02.00 ROOF PLANTS & EXTENSIONS - PROPOSED AMENDMENTS

Planning Application 2020/1350/P

**PROPOSED
AMENDMENTS VIEWS**

02.12 (NORTH) EAGLE STREET ELEVATION

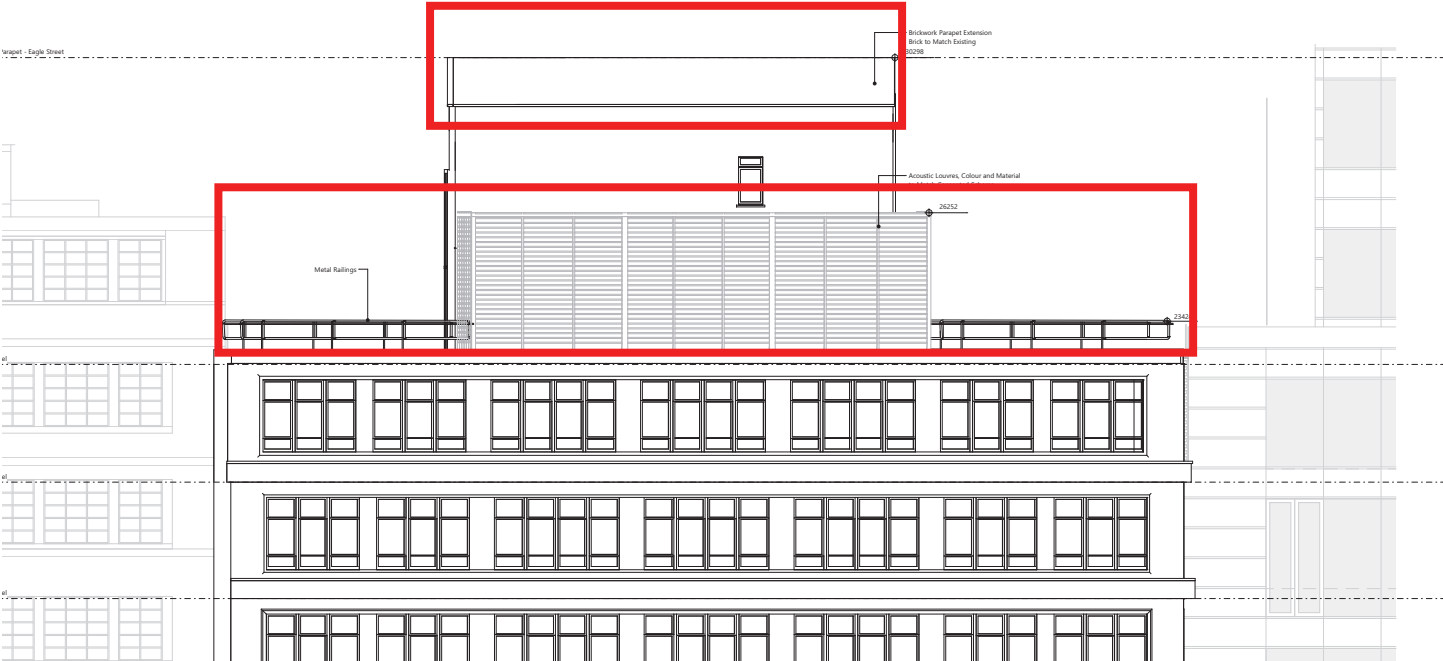
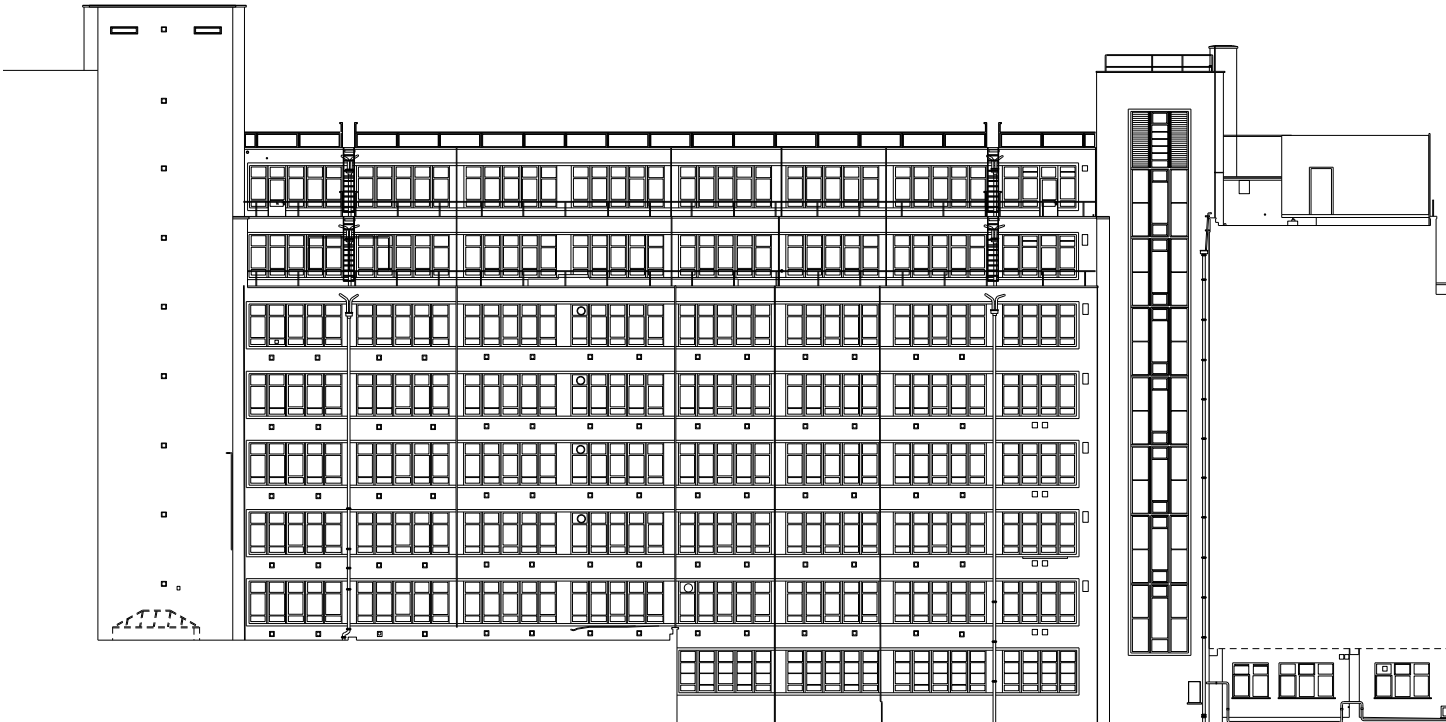
- Plant acoustic screening extent reduction. Height and footprint as existing. Colour and materiality to match consented scheme.
- New metal railings to Eagle street front and back parapets.

- Brickwork parapet extension. Brick to Match existing.

02.14 EAST ELEVATION

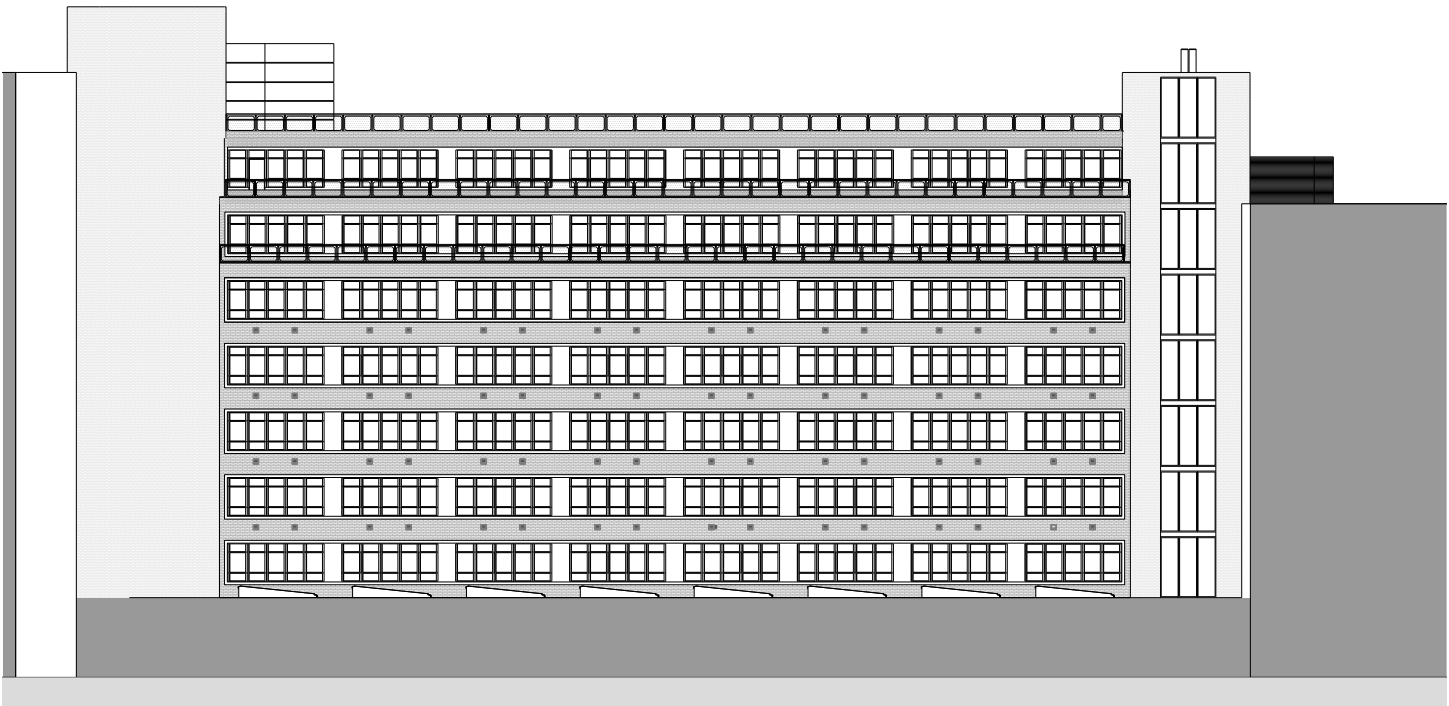
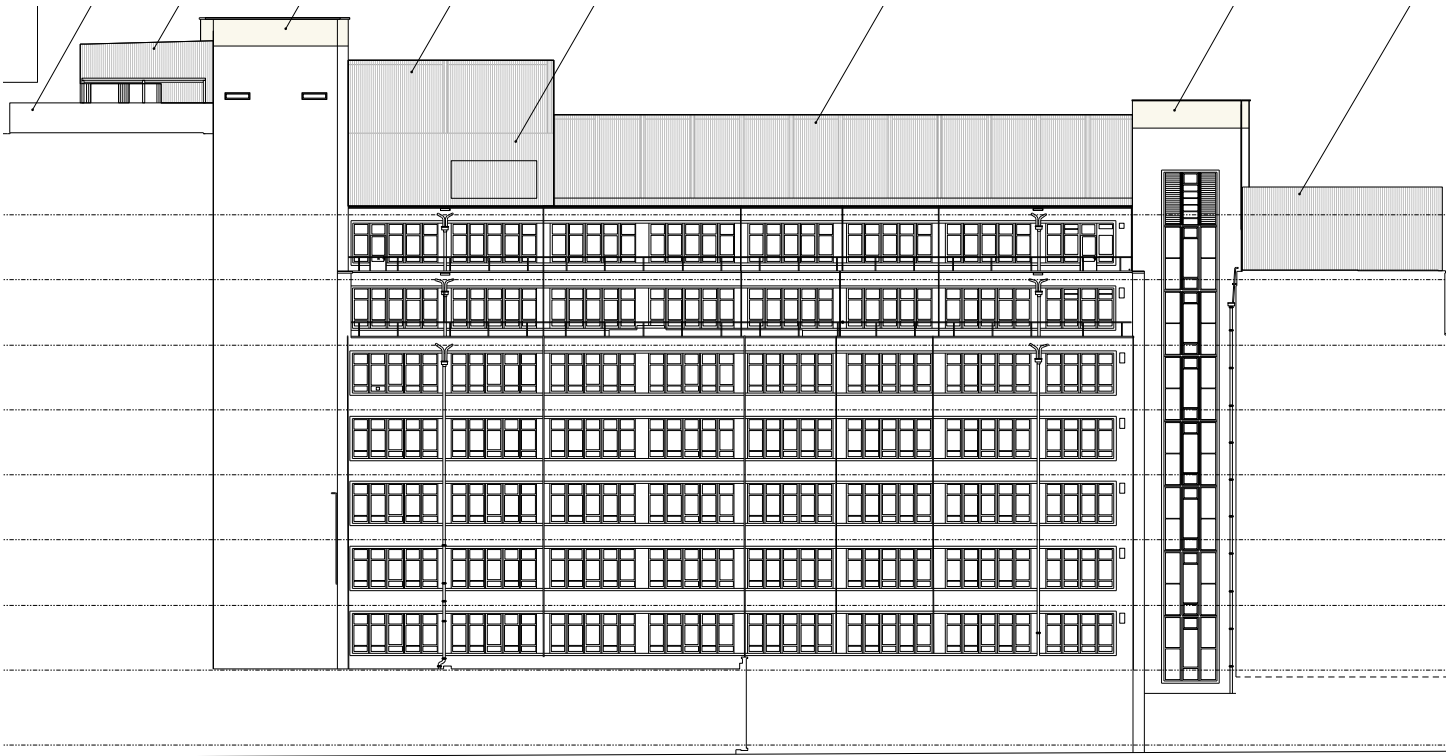
- Toilet block extension omitted.
- Plant acoustic screening height reduced . Colour and material matching consented scheme.

02.16 (SOUTH) HIGH HOLBORN ELEVATION

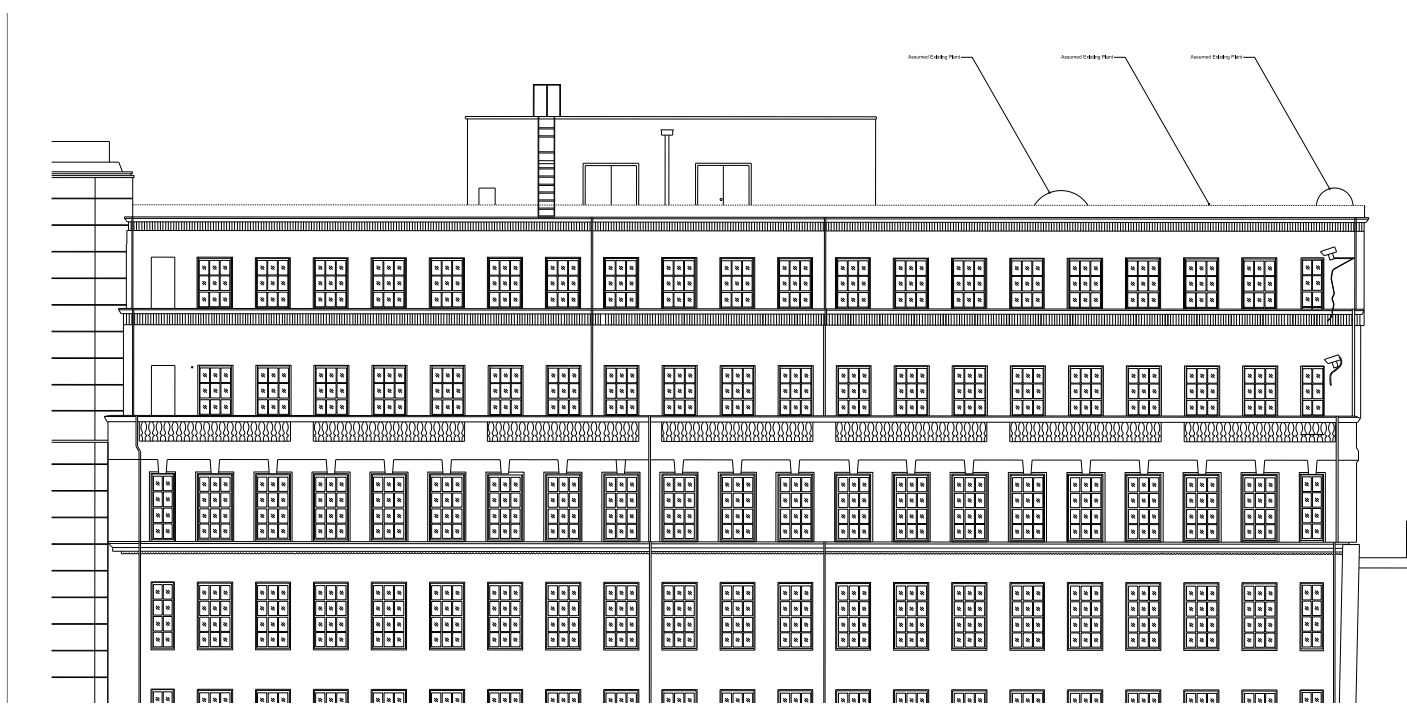
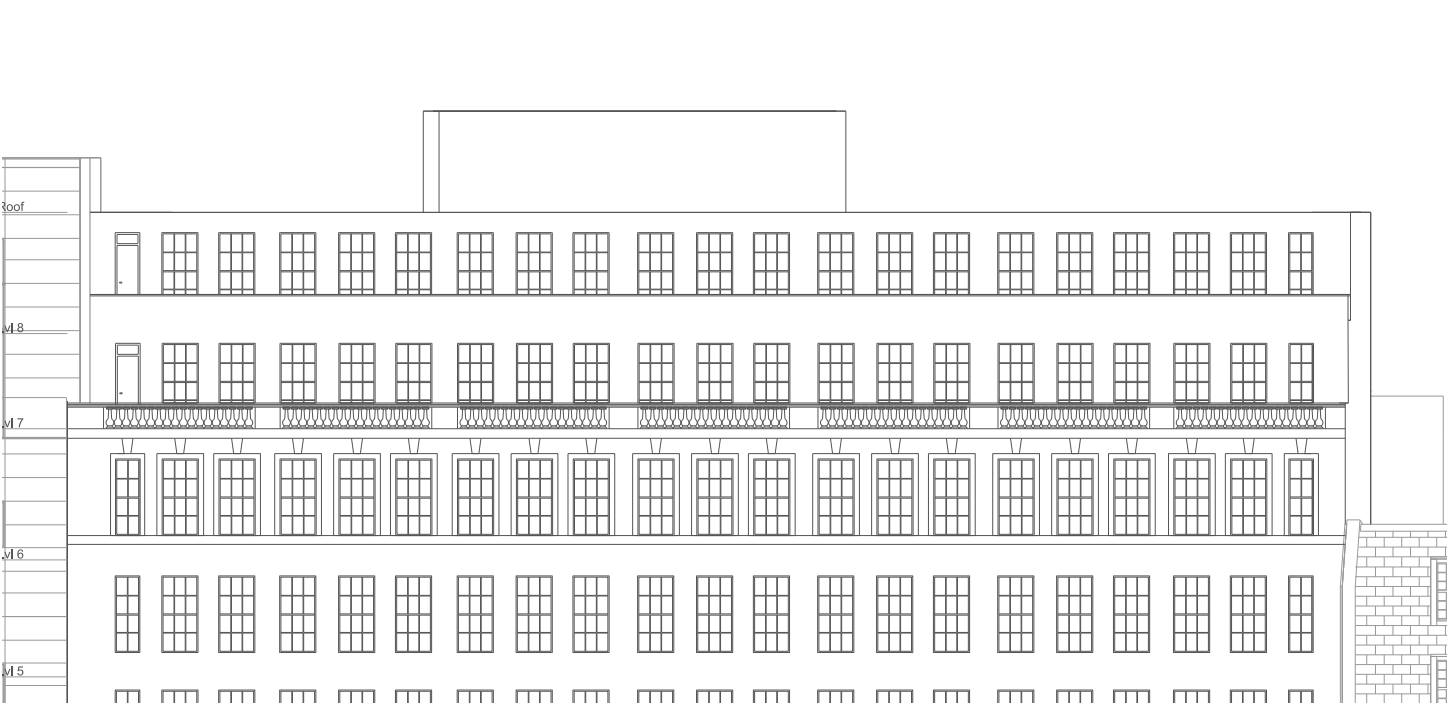
- Omission of plant equipment and enclosure, plant relocated to link block roof.
- New metallic railing to match consented scheme on all sides of the accessible roof
- Relocation of covered terrace to be centered with core. Height reduced and appearance to match consented scheme.
- Height reduction of High Holborn Core parapet.

02.18 WEST ELEVATION

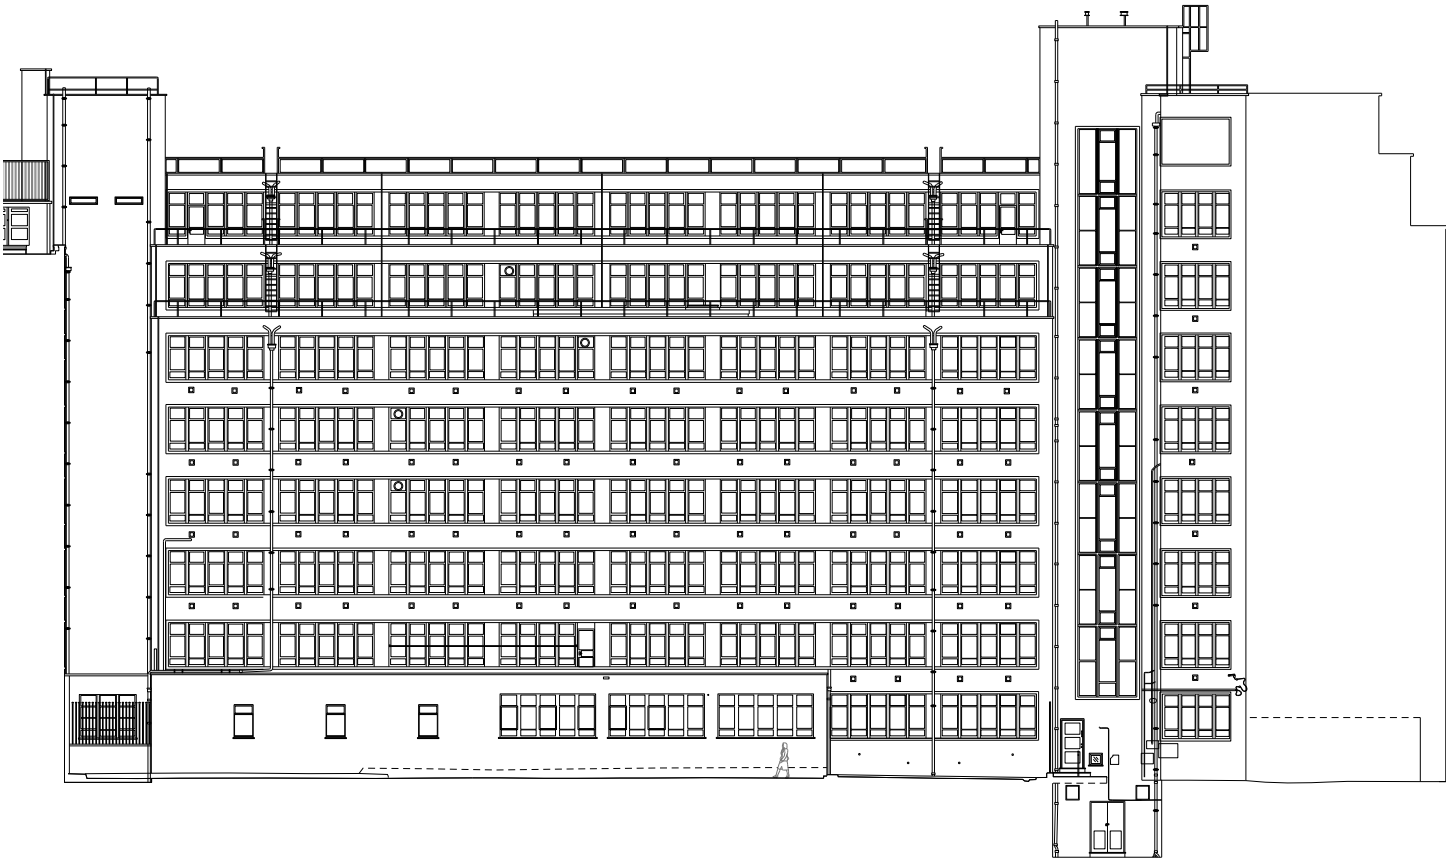
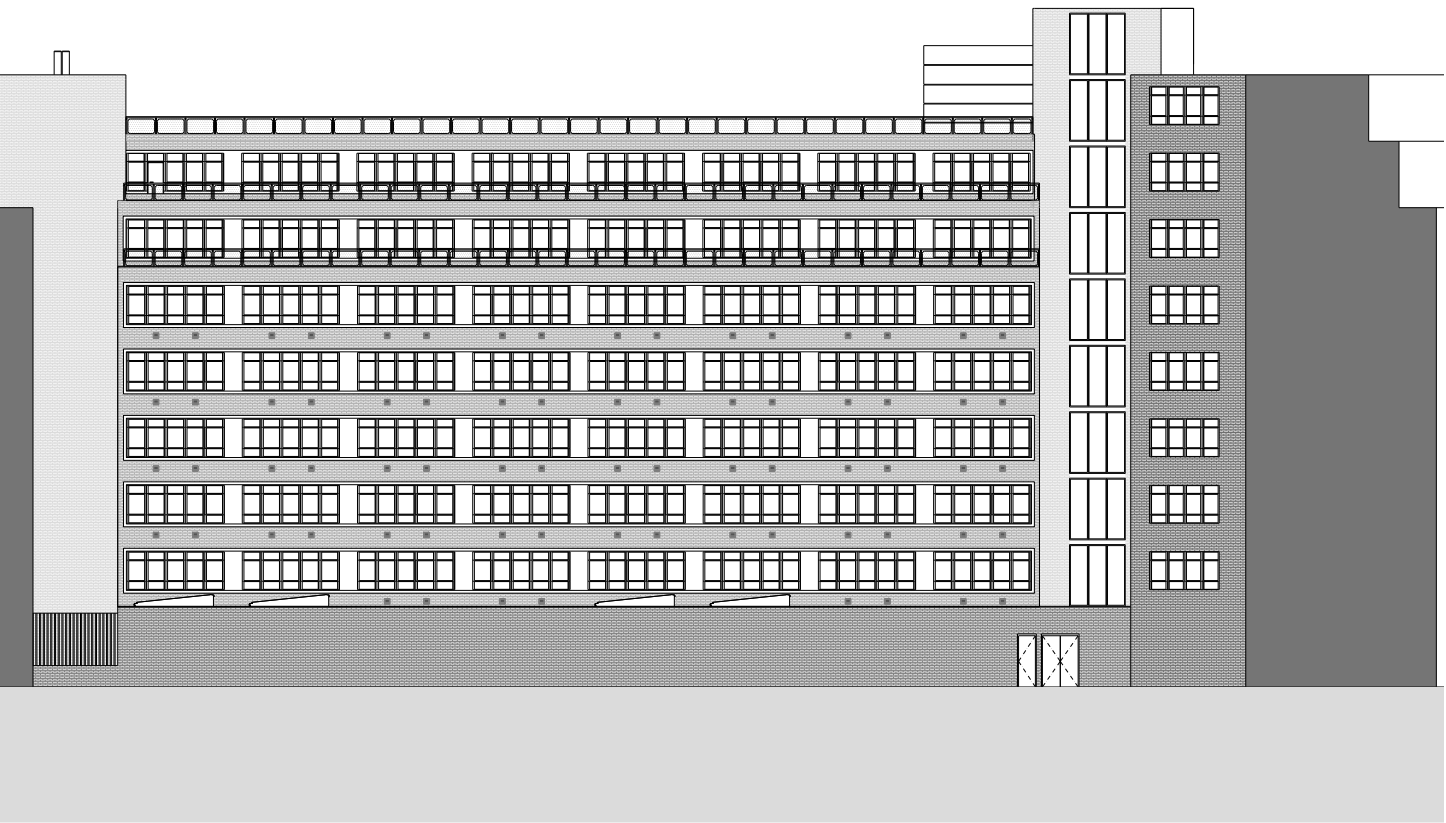
- Toilet block extension omitted.
- Plant acoustic screening height reduced . Colour and material matching consented scheme.

- Omission of plant equipment and enclosure, plant relocated to link block roof.
- New metallic railing to match consented scheme on all sides of the accessible roof
- Relocation of covered terrace to be centered with core. Height reduced and appearance to match consented scheme.
- Height reduction of High Holborn Core brick parapet extension. Brick to match existing.

02.00 ROOF PLANTS & EXTENSIONS - PROPOSED AMENDMENTS
02.20 SECTION AA

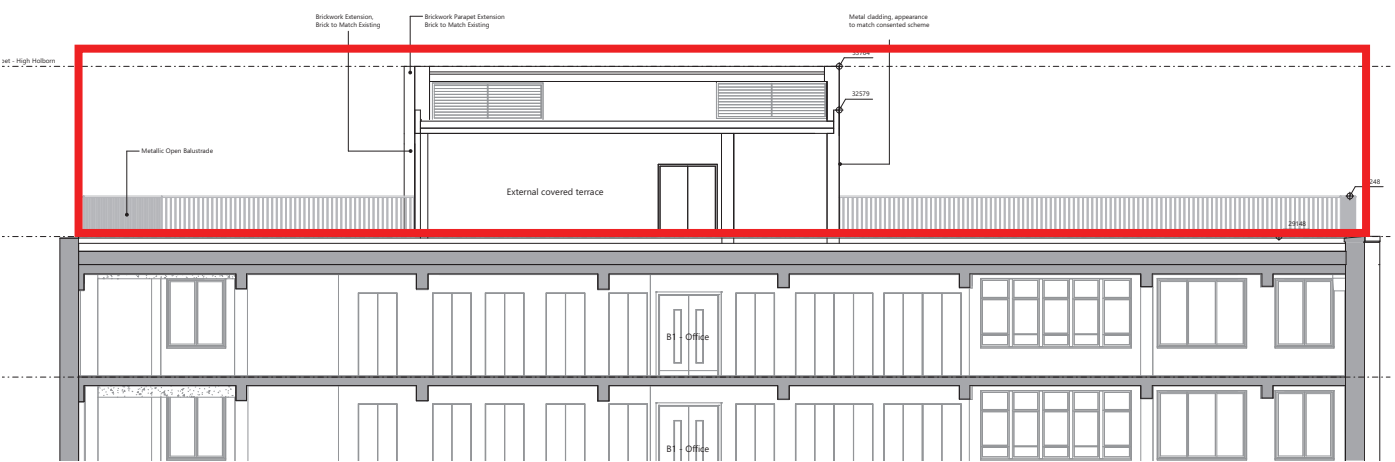
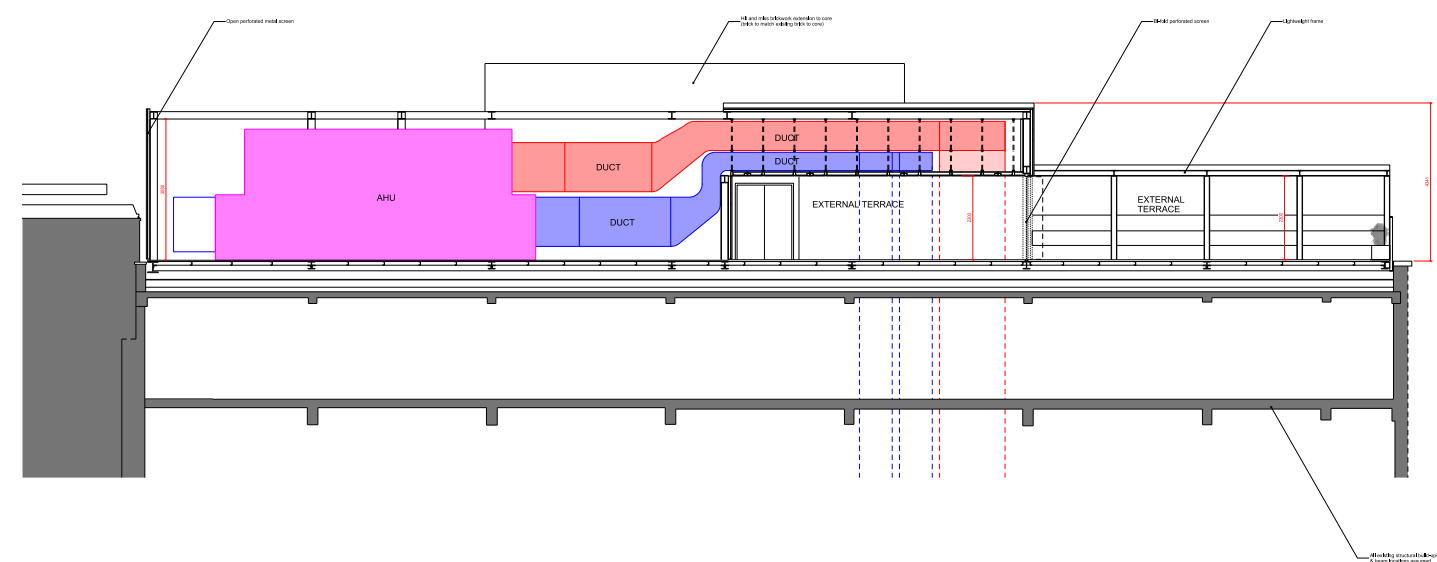
- HIGH HOLBORN BLOCK
- Omission of plant equipment and enclosure, plant relocated to link block roof.
 - New metallic railing to match consented scheme on all sides of the accessible roof
 - Relocation of covered terrace to be centered with core. Height reduced and appearance to match consented scheme.
 - Height reduction of High Holborn Core brick parapet extension.
